1445 NEW YORK AVENUE NW

PROPOSED RENOVATIONS

COMMISSION OF FINE ARTS

CONCEPT REVIEW SUBMISSION

STUDY | PUNCHED COPPER | TO 06

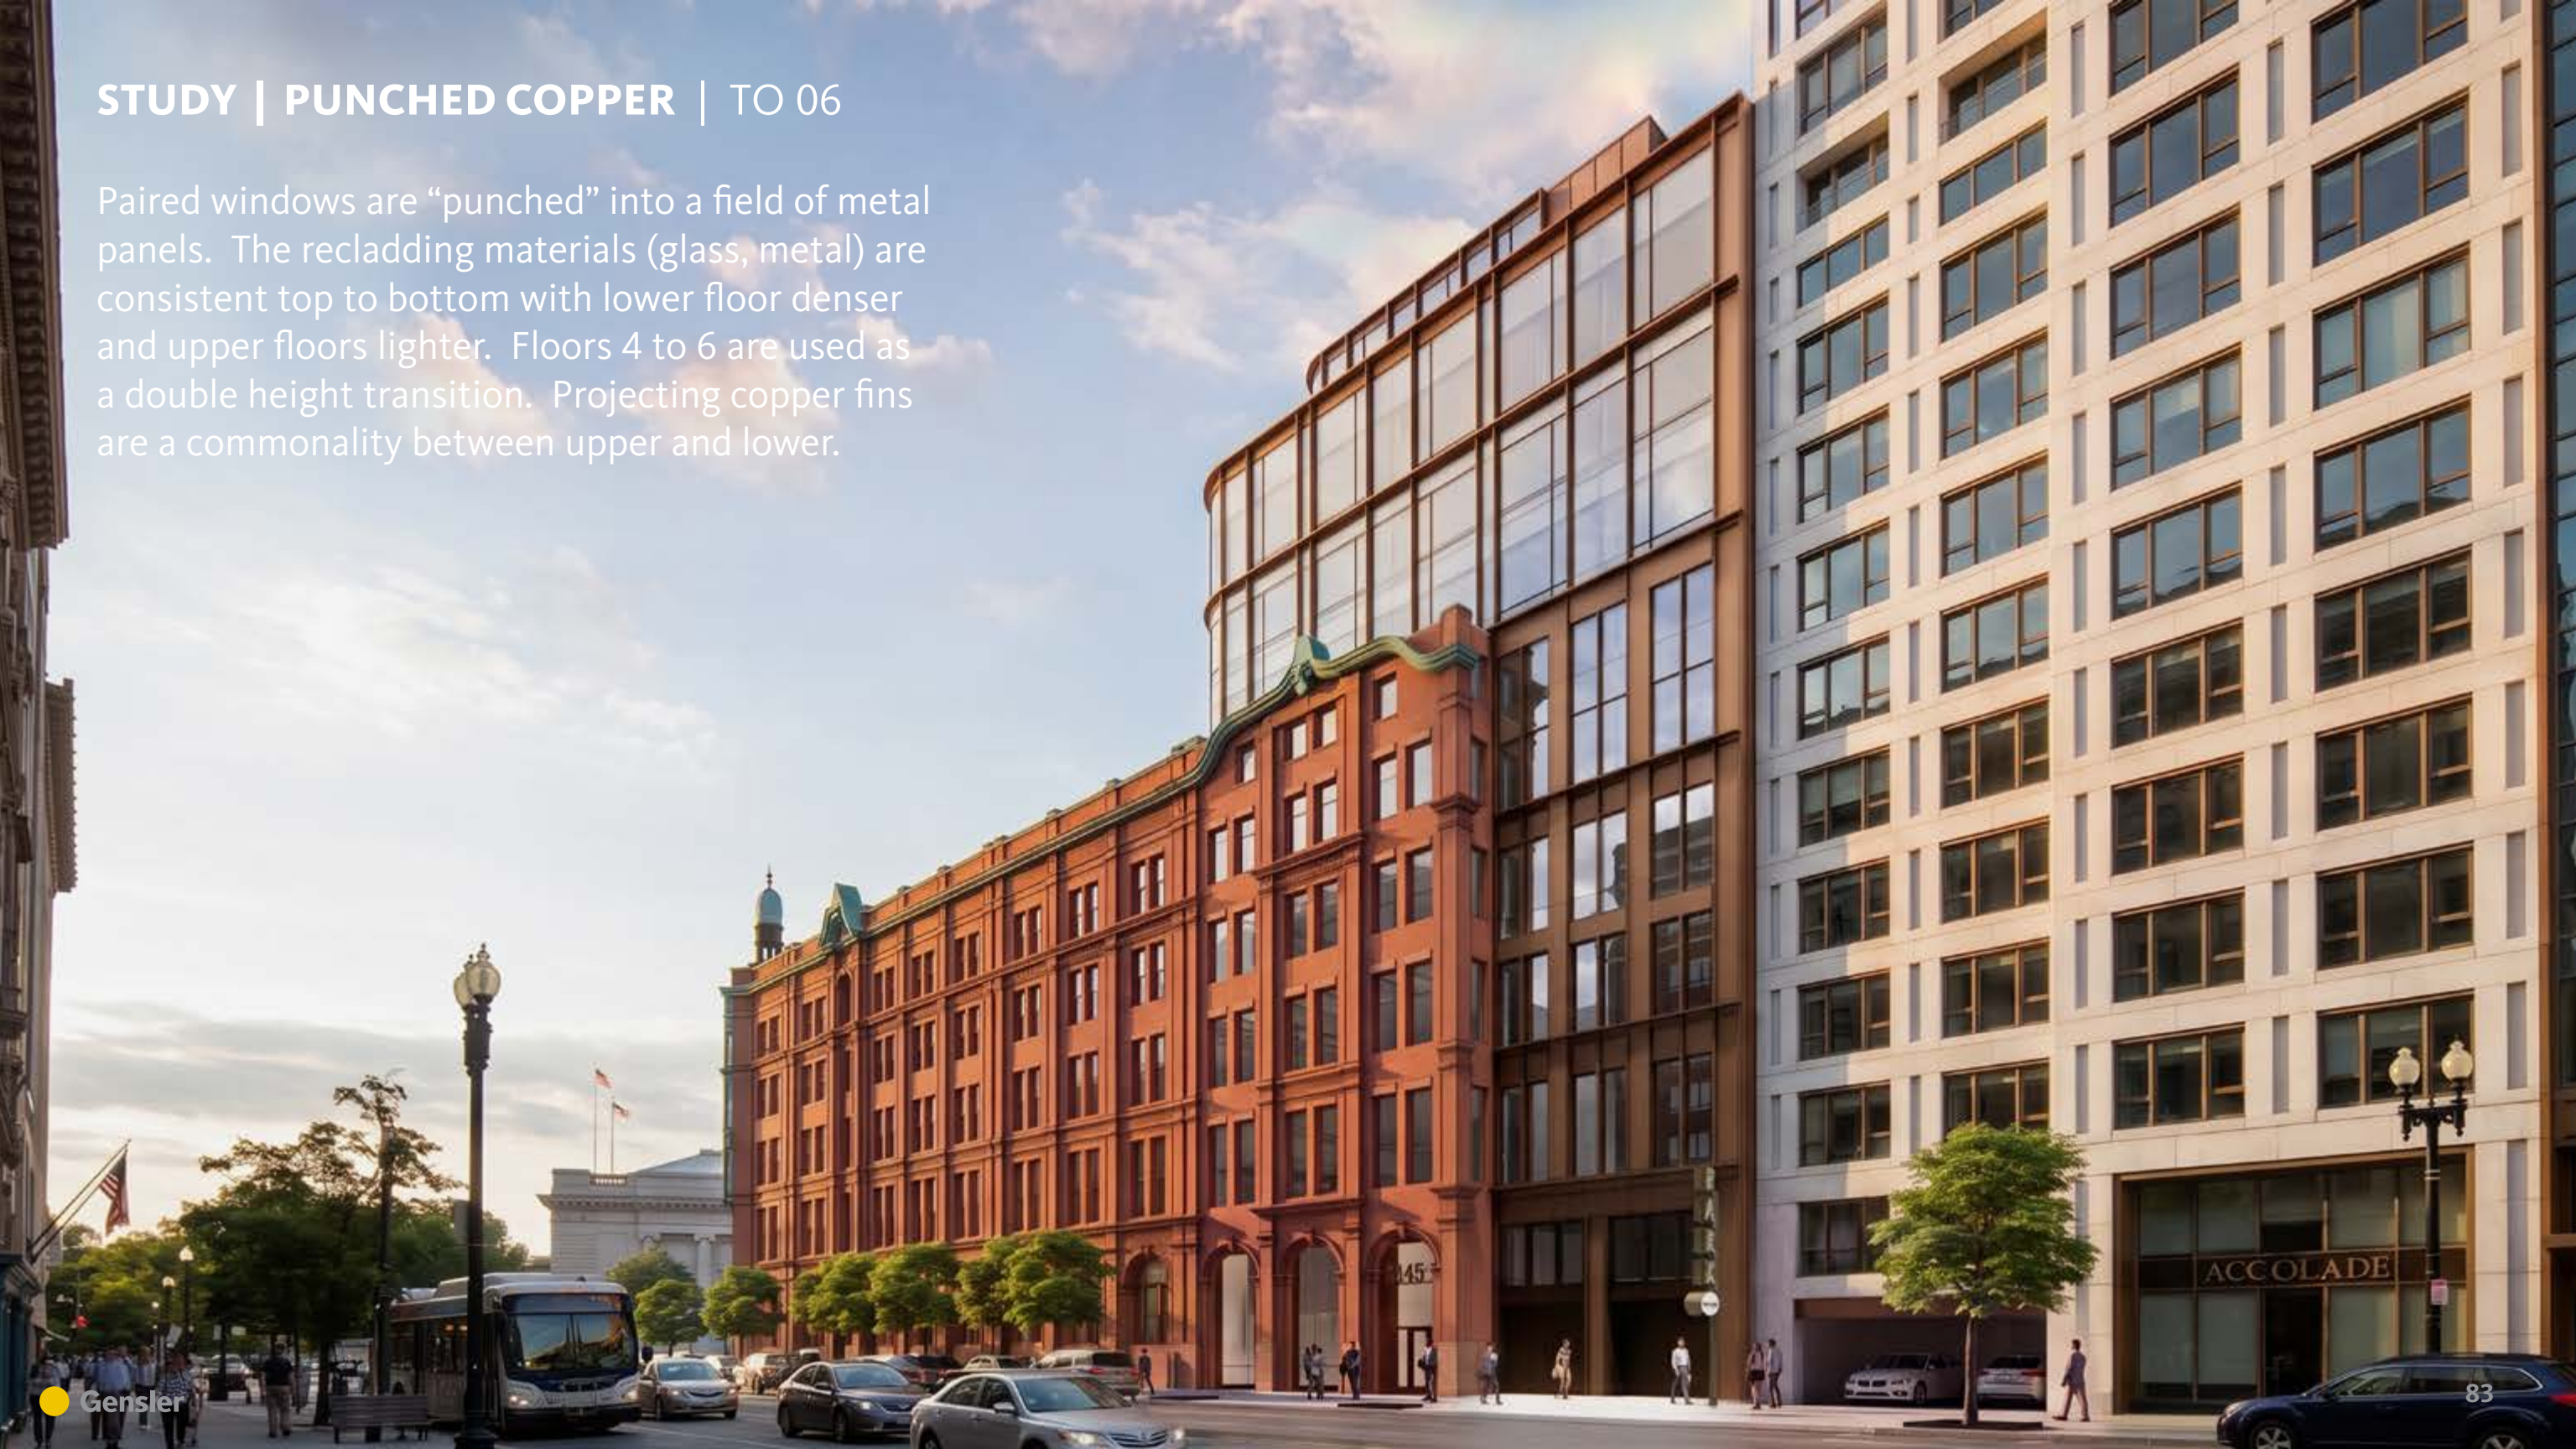
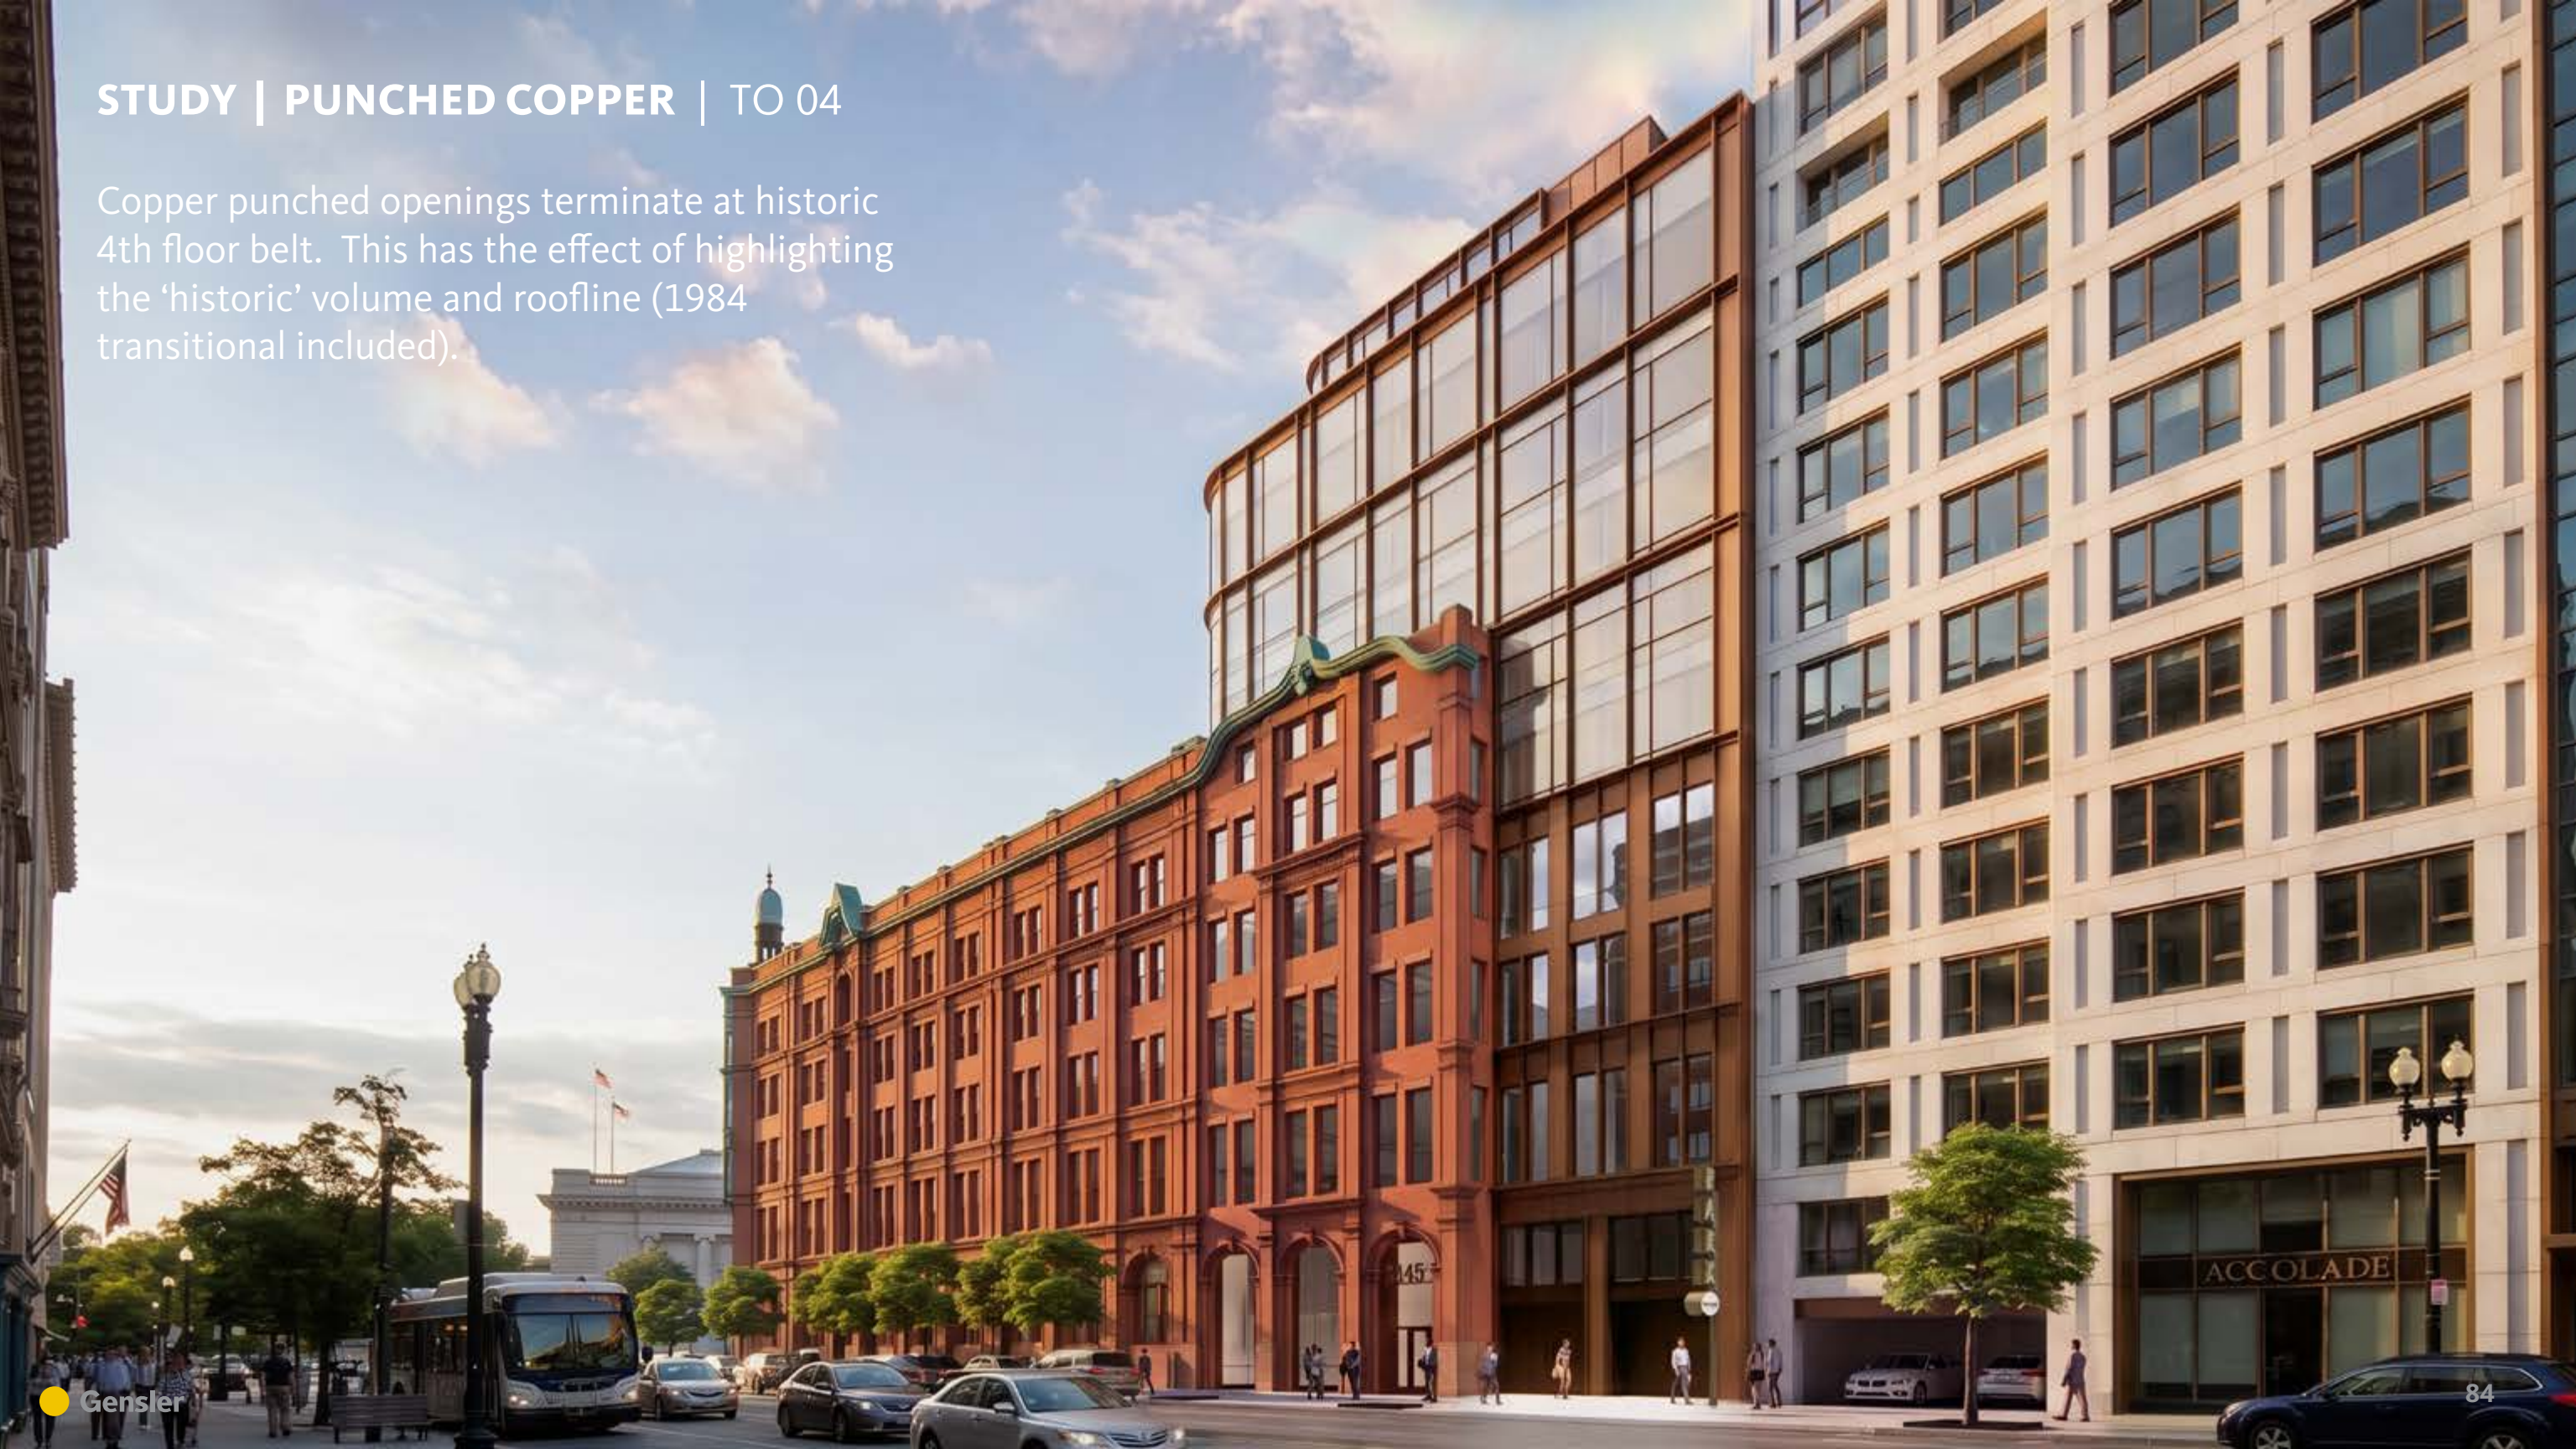
This area is recalling DC's unfortunate history with "façadomies." Study using brick up to the historic roofline and transitioning to glass above. Study extending new façade down to grade.

Paired windows are “punched” into a field of metal panels. The recladding materials (glass, metal) are consistent top to bottom with lower floor denser and upper floors lighter. Floors 4 to 6 are used as a double height transition. Projecting copper fins are a commonality between upper and lower.

Copper punched openings terminate at historic 4th floor belt. This has the effect of highlighting the 'historic' volume and roofline (1984 transitional included).
